UNITED STATES PATENT AND TRADEMARK OFFICE

APPLICATION NO.	FILING DATE	FIRST NAMED INVENTOR	ATTORNEY DOCKET NO.	CONFIRMATION NO.
10/717,256	11/19/2003	Erich Schwaerzler	12761/293065	7703

Office Action Summary	Application No.		Applicant(s)	
	10/717,256		SCHWAERZLER ET AL.	
	Examiner		Art Unit	
	Noah C. Hawk		3637

DETAILED ACTION

Delmege et al., Figure 2

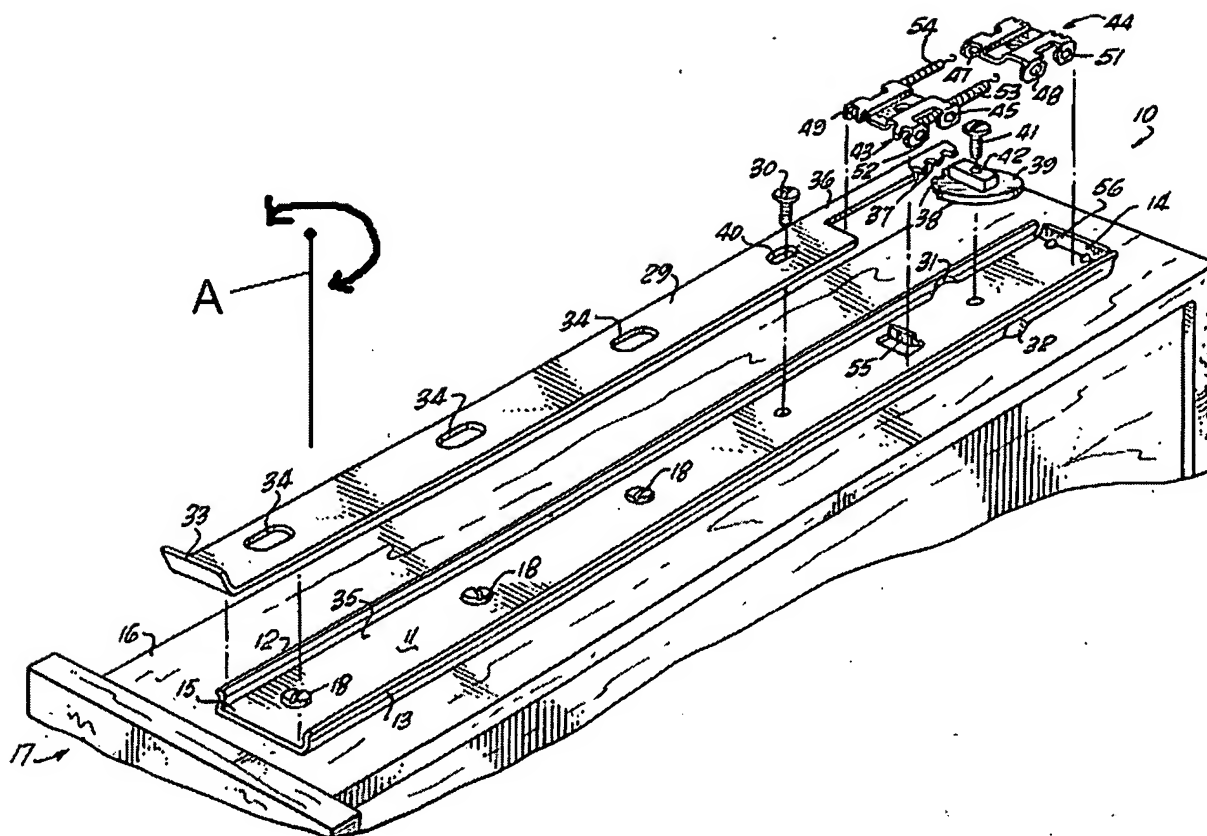
a. Regarding Claim 1, Delmege et al. disclose a panel adjustment device as structurally claimed for a drawer equipped with a front panel and located in a cabinet by means of a rail system with at least one each of a drawer rail (11) and a cabinet rail (19) which panel adjustment device is suitable for changing an enclosed inclination angle between a vertical level of a front fore side of the cabinet and a vertical level of the front panel of the drawer, the panel adjustment device comprising a lifting and lowering device (the combination of 29, 33, 36, 41, and 39) that works between the drawer and the drawer rail to swivel the drawer relative to the drawer rail about a swiveling axis, the lifting and lowering device further comprising a lifting and lowering element (39) so that a swiveling of the drawer and with it the front panel of the drawer is possible around the swiveling axis (A) and wherein the swiveling axis is disposed between the front panel of the drawer and the lifting and lowering element and a distance between the swiveling axis and the front panel is not greater than a distance between the swiveling axis and the lifting and lowering element.

b. Regarding Claim 2, Delmege et al. further disclose a panel adjustment device wherein the swiveling axis (A) is closer to the front panel of the drawer than to the lifting and lowering element of the lifting and lowering device (best seen in Delmege et al., Figure 2).
